From: [REDACTED]
To: [Luton Airport](#)
Subject: The expansion plans for London Luton Airport
Date: 30 August 2024 16:15:26
Attachments: [RELAS AD6 Stage 7 Common Submission version 1.0 compressed \(1\).pdf](#)

RELAS AD6 Stage 7 Common Submission

Version 1.0 - 27 August 2024

Figure 6 LLA Arrivals to Runway 25 descending from 12,000ft-8,000ft showing ZAGZO hold (north), 7 days in June 2023 post-airspace change

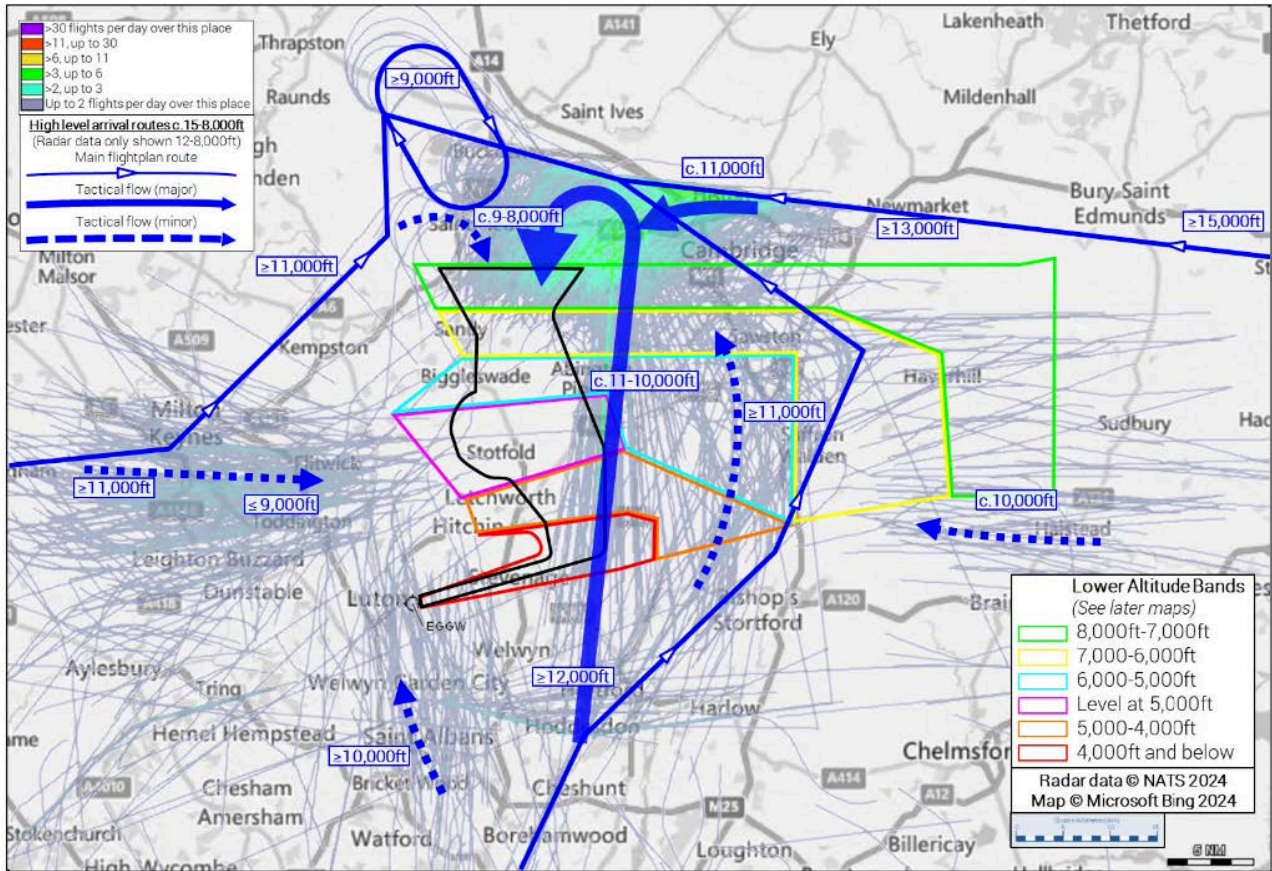
The Tactical Flow diagram in CAP1616 AD6 Stage 7 Post-Implementation Review Annex A, reproduced below, provides the NATS/LLA interpretation of the actual traffic distribution flow. This is substantially different from the AD6 expectation outlined in the previous section, as will be explained in more detail:

The 7 day sample period selected by NATS as 'representative' used in the previous diagram does illustrate the issues described in this report, but is not fully representative of flights over a longer summer reporting period.

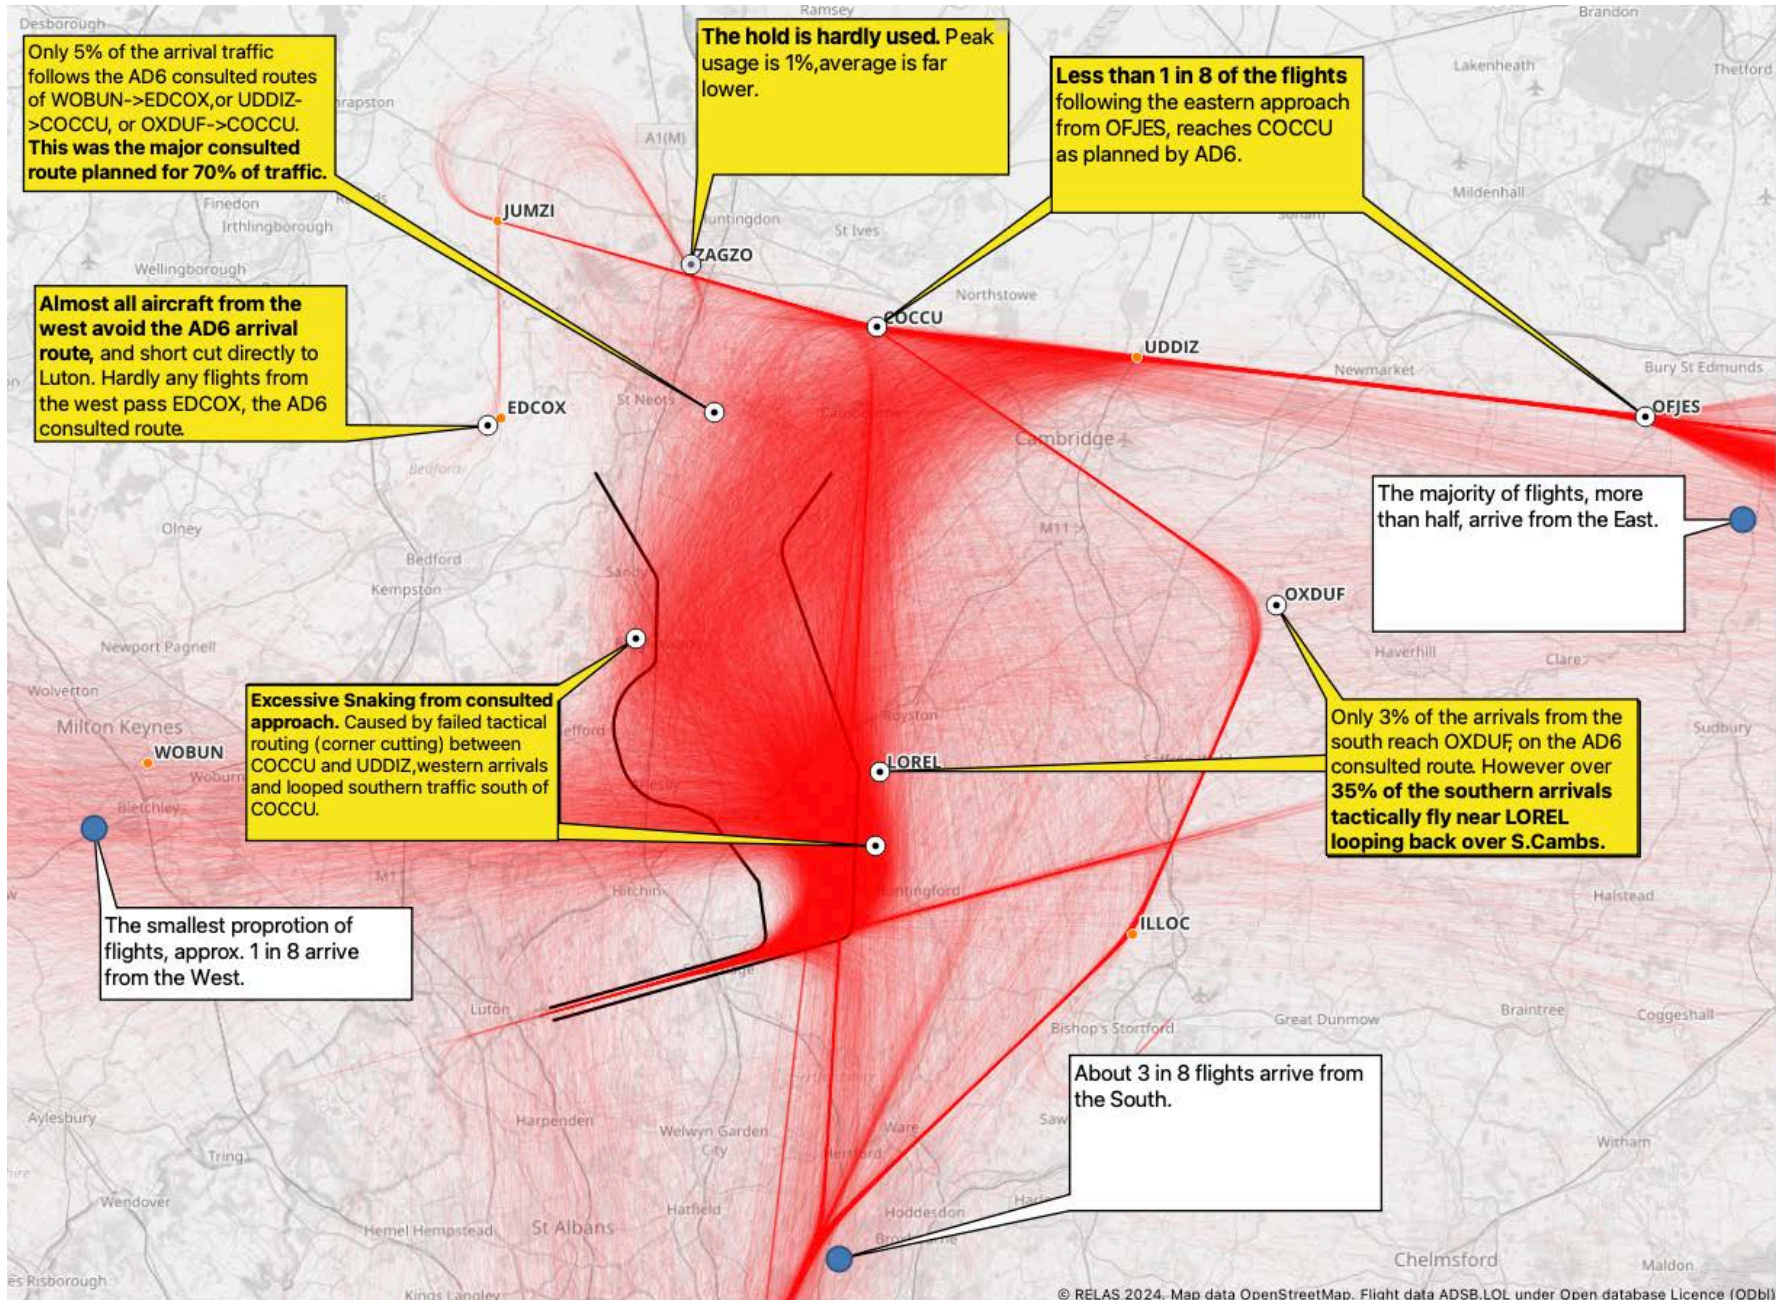
Traffic over the longer period shows more pronounced 'S' flights within the vector area, and some changes to the flight pattern, especially from the south.

1. **The 'tactical flows', that were not consulted, have become the major flight path routes**, operating 24 hours a day.
2. **All the planned and consulted strategic routes are largely unused.**

- d. The worst overflight areas are not visible as they are overdrawn by the tactical flow arrows graphics.

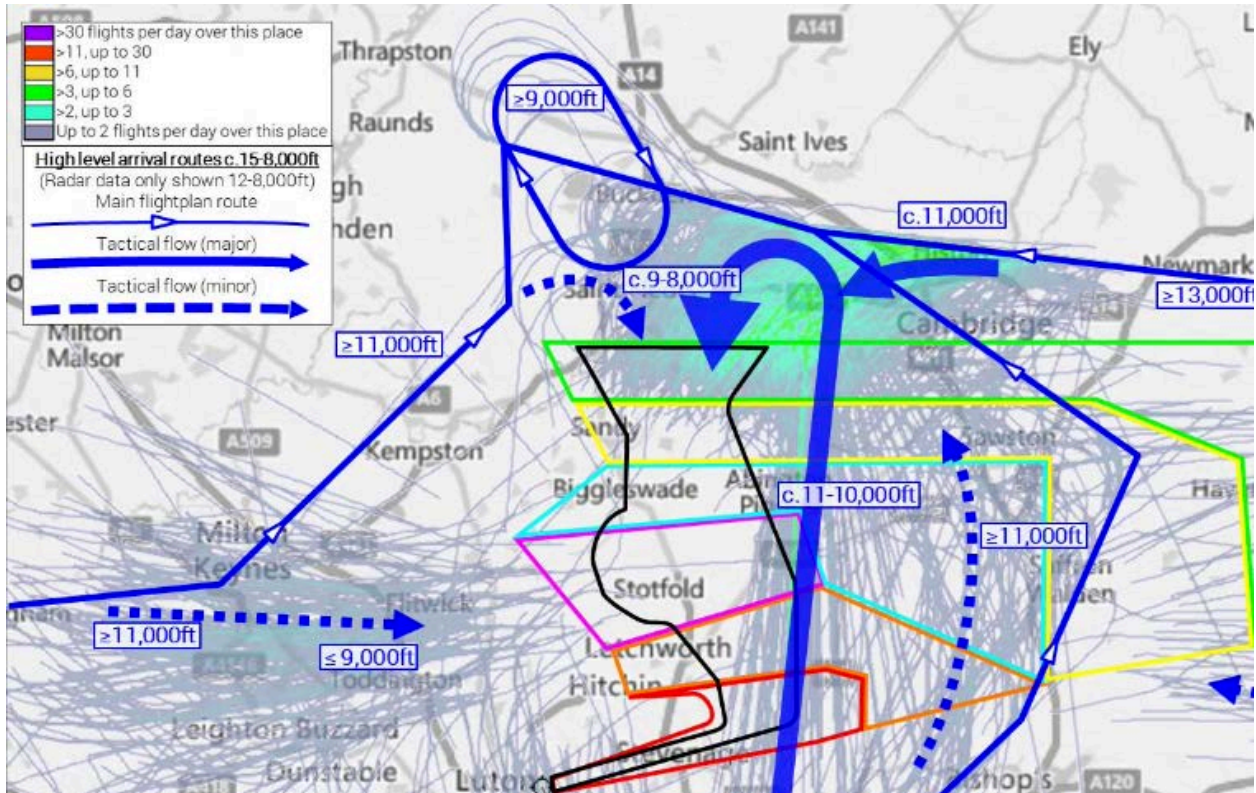
It is unclear how the PIR report on overflights in Annex A was calculated. The NATS Tactical Flow diagram, enlarged and reproduced below, shows at most 6 overflights north of Biggleswade. Note the faint green glow to the west of Cambridge.

Residents report of 50+ overflights a day. So we would have expected the above diagram to be covered by large blocks of red or purple. We have independently repeated the analysis below. **The diagram below is generated by RELAS, and coloured using the same key as above, eg cyan : 2-3 overflights per day, green : 3-6 overflights per day etc. We have added an additional element to the key - very dark brown/purple for >50 overflights per day.**

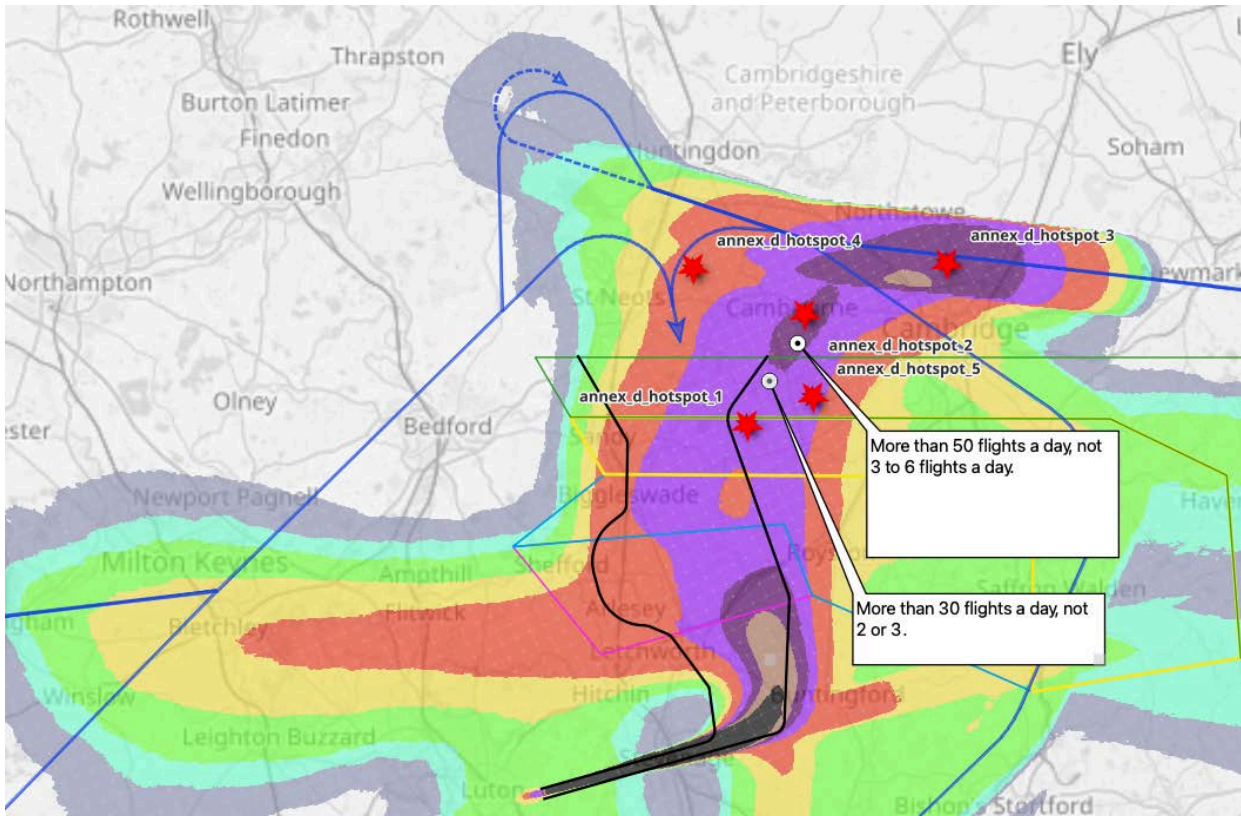
In detail, the number of overflights is plotted using the exact CAP1498 'inverted cone' methodology, over a 100m grid, but we have extended the height to 12,000 ft for direct comparison with the overflight data in the earlier NATS/LLA diagram.

As can be seen from the diagram many areas in South Cambridge have over 50 flights a day³, while the PIR Tactical Flow diagram shows at most 6 per day across this area. Interestingly, the **count of at least 50 flights per day is consistent with the estimate modelled in the PIR Noise Report (Fig 35)**

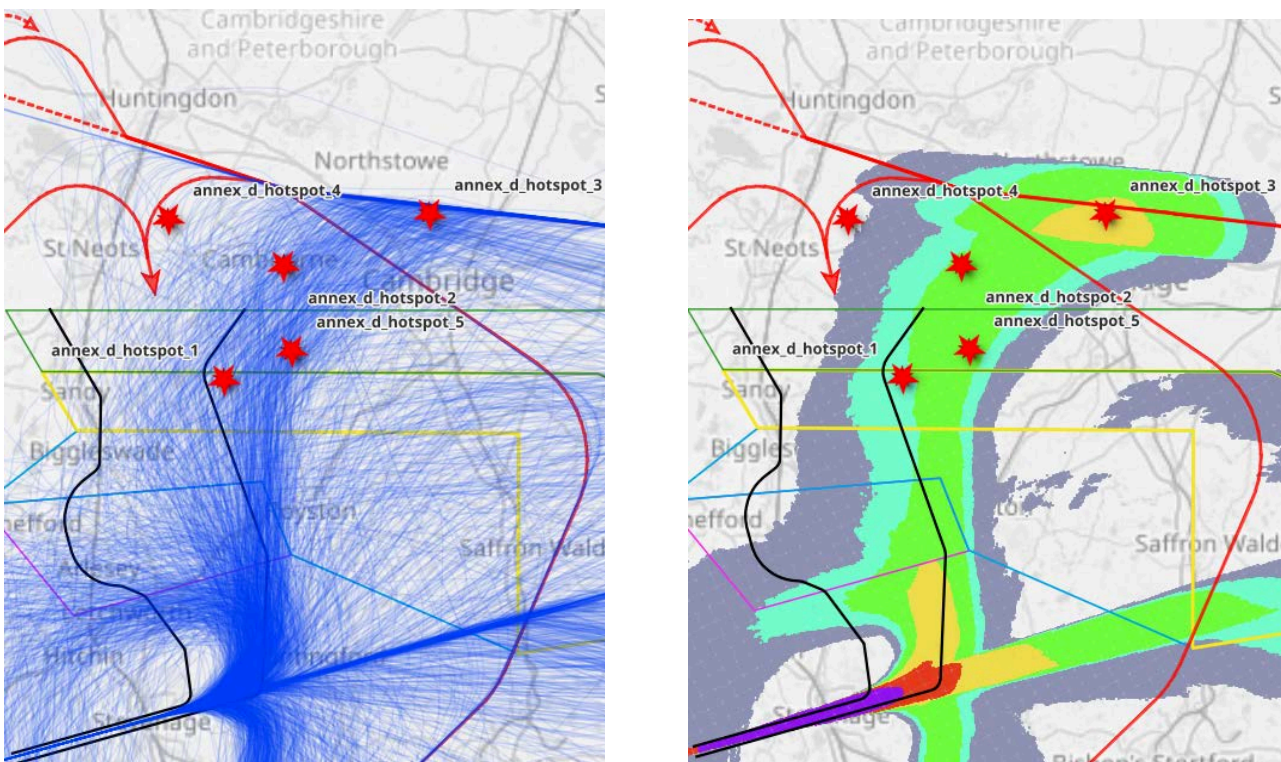
The diagram to the left shows all the nightflight tracks for all arrivals from all directions using the westerly runway in the CAP 1616i compliant monitoring period (16 June to 15 September 2023). The night flights are shown as both track plots (on the left) and an overflight diagram (on the right). This uses the same colour key (but in this case night time only) as the previous plots. Again this is CAP 1498 compliant, extended beyond 7,000ft to be consistent with the original NATS diagram above in Section 2.4.2. Night time is from 23:00 to 07:00 local time.

The locations of some complaint hotspots can be seen under high concentrations of night flights. **This is a key future concern with the very significant proposed 70% increase in night flights with Luton expansion.**

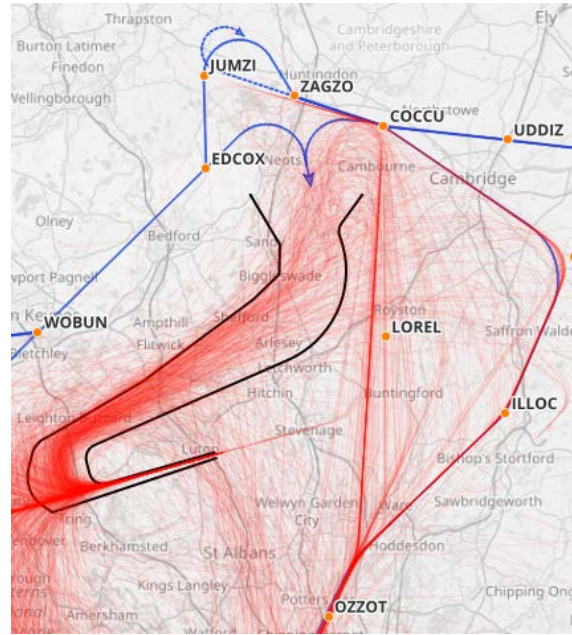
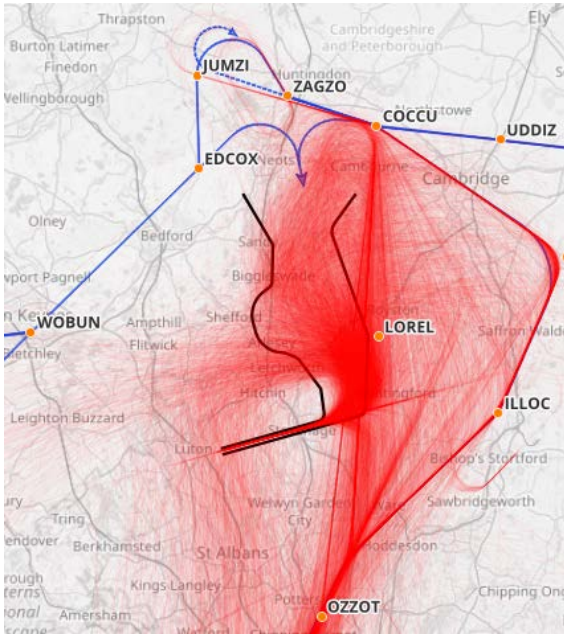
The following diagrams show the "tactical route" of traffic arriving from the south passing LOREL is actually a dominant route. Less than 3% of traffic originating in the south follows the route past OXDUF and COCCU to the westerly runway.

The tactical route results in many properties being overflowed twice by the same aircraft with just a few minutes separation. Above especially on the left diagram, **many flight paths can be seen to cross themselves**.

Establish Track Distance For Consulted Path Is 80km or greater

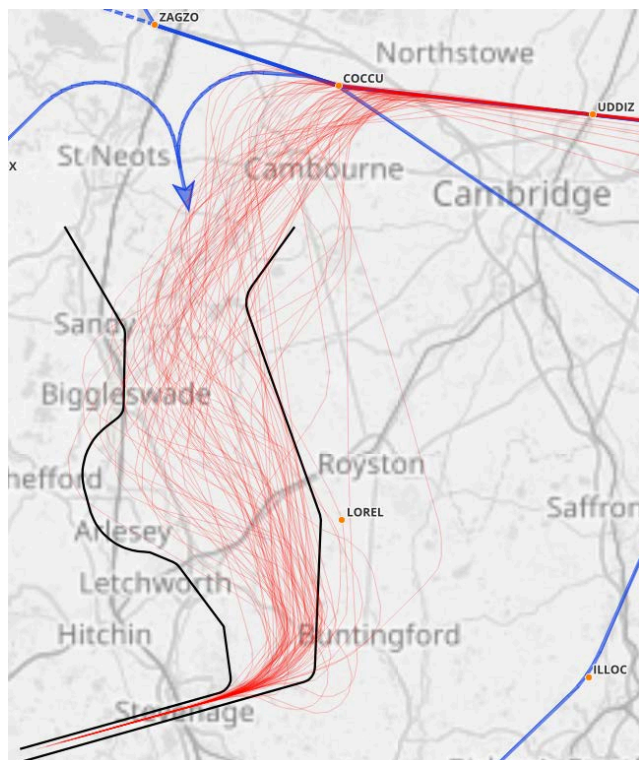
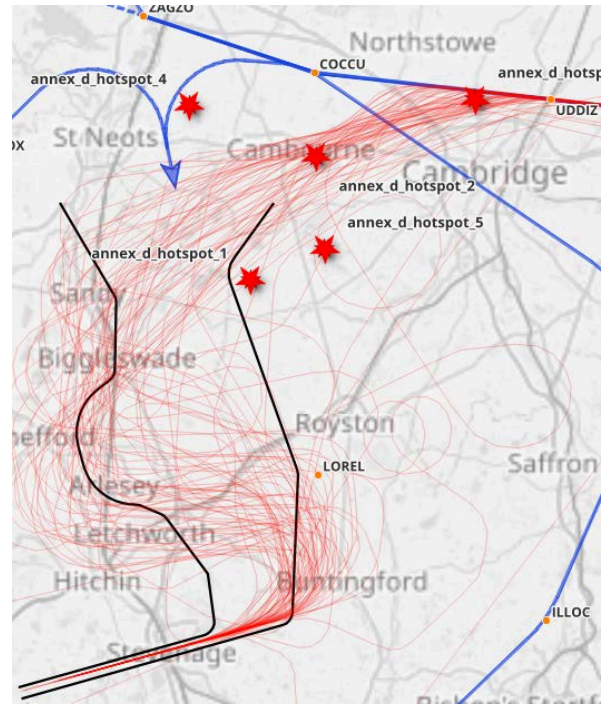
The track plots below show that many of the tactical flows 'fail'. They are not shortcuts, but deliver over the ground distances at least as long as the consulted path.

This plot is for flights where track distance actually flown from UDDIZ to the runway is **80 km (43 nm)**. These give representative flights following the consulted path close to COCCU, then staying within the vectored space are shown here.

Stated simply any arrival flying longer than 80km is not a shortcut from the consulted arrival path.

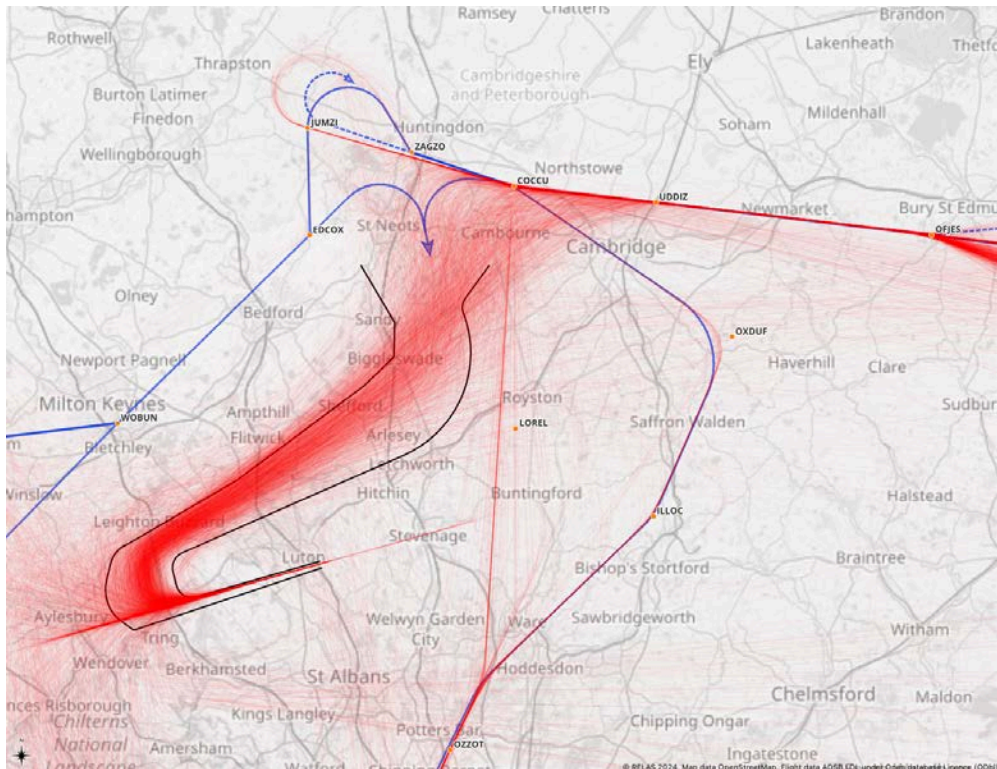
Below is a diagram of the Eastern runway in use for the same 16 June to 15 September 2023 core monitoring period. Flights originating from all directions are shown. As can be seen comparing these easterly and westerly arrivals most of the issues described above also apply for these easterly arrivals.

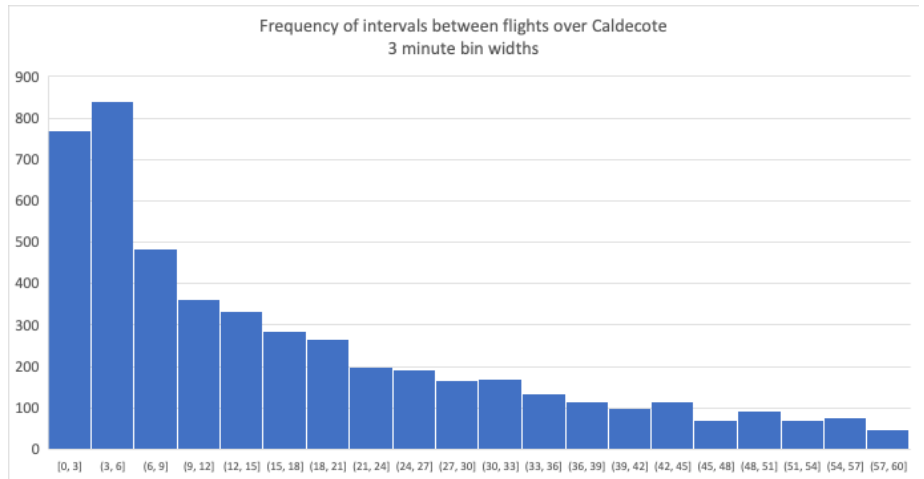
The noise and disturbance caused by 'Convoys' [i.e. high frequency flights over a narrow area in a short period] of aircraft can be seen in the histogram to the right. Here we show the interval, in minutes, between flights passing over an unconsulted village in CB23.

So, there were 770 occasions when the aircraft were less than 3 minutes apart, and 841 occasions with aircraft 3-6 minutes apart. Over the 118 days, there were on average 6.5 pairs of flights in very rapid succession per day, with many of them forming tight, intrusive, convoys.

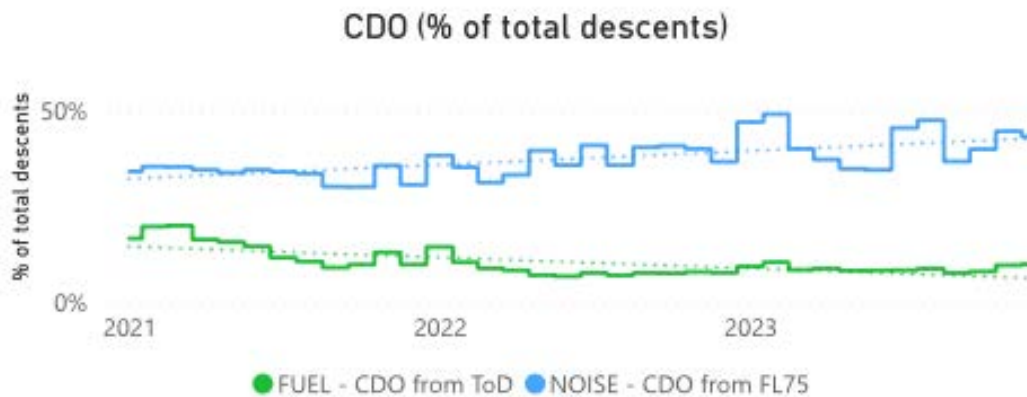
In the chart below (from Eurocontrol), the vertical axis shows the percentage of LLA arrivals achieving CDO.

- The blue line shows the percentage achieving CDO from FL75, where under ANG2017 noise is the priority.
- The green line shows the percentage achieving CDO from Top of Descent, where under ANG2017 CO2 efficiency is the priority.
